2000P07639US01; 60,427-252

REMARKS

CLAMPLESS HOSE RETAINER MECHANISM Applicant: Stuart; Serial N . 09/838,472 REPLACEMENT SHEETS

Fig-3

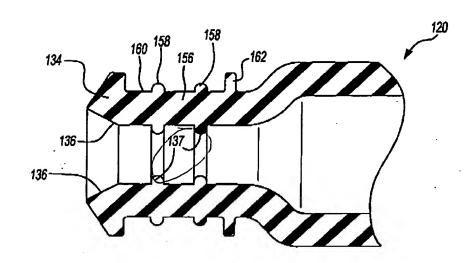
Figure 2 and 3 have been amended. The line extending from reference numeral 44 in Figure 2 has been shorted to point to the tapered insertion end, as described in the specification. The reference numeral 137 pointing to the angled face of the tube 120 has also been changed to "136." Applicant is filing revised formal drawings reflecting these changes with this Amendment.
